Re: Zibi Ontario Phase 1A Response to City of Ottawa Comments related to Transportation

This letter report has been prepared to address to the transportation-related comments received from the City of Ottawa, dated November 24th, 2015 on the preliminary circulation of the Site Plan Application for Zibi Ontario Phase 1A. Previous transportation planning documents prepared by Parsons for the proposed development include: *Domtar Lands Redevelopment - Multi-Modal Transportation Impact Study* dated 21 April 2014; and *Zibi Ontario Phase 1A Transportation Impact Study* dated 4 September 2015. A *Preliminary Multi-Modal Assessment of the Booth Street Corridor* dated 10 December 2015 has also been completed to assist in formulating a construction phasing plan for Booth Street. This was submitted to the City of Ottawa, and is attached.

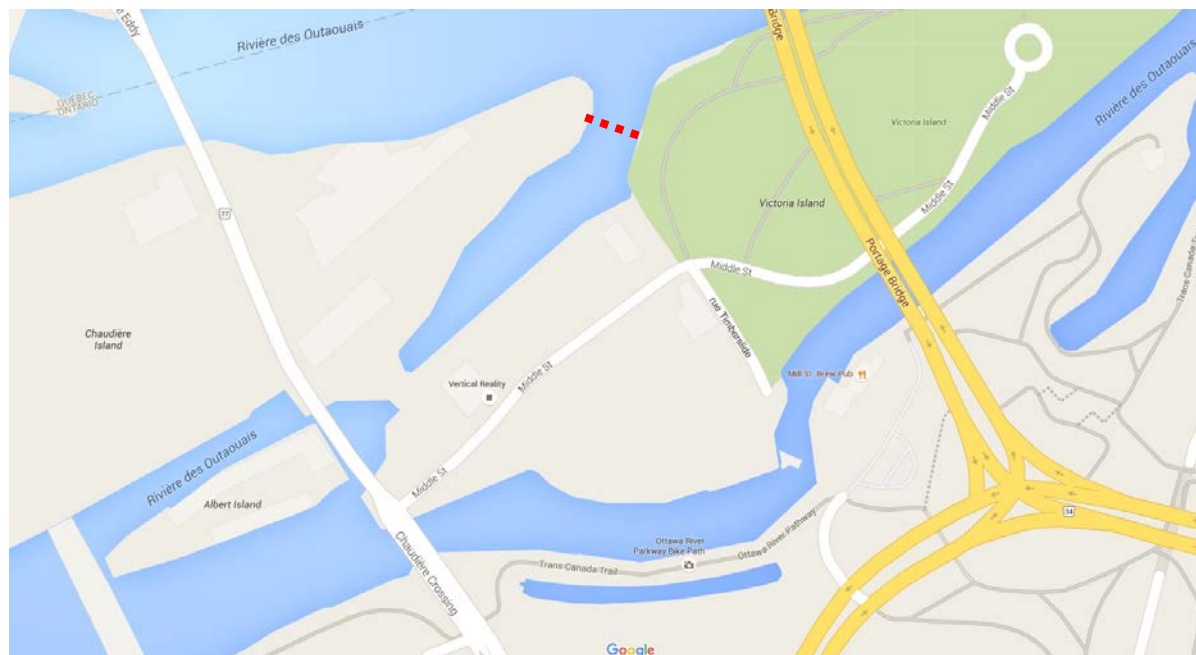
118. As part of the development approval, the proponent should provide a multi-use pathway bridge from the end of Chaudière Island over the sluice channel to the north end of Victoria Island. This distance of approx 40 to 45 metres could be spanned by prefabricated bridge structures such as used in other locations along the Capital Pathway system. This would provide a choice not to travel along Booth and

more direct pedestrian access to sidewalks and buses on the Portage Bridge and to the cycling facilities as well.

Parsons Response: *This location (see map) is not within Phase 1A, but the concept is one that needs to be discussed with the Proponent.*
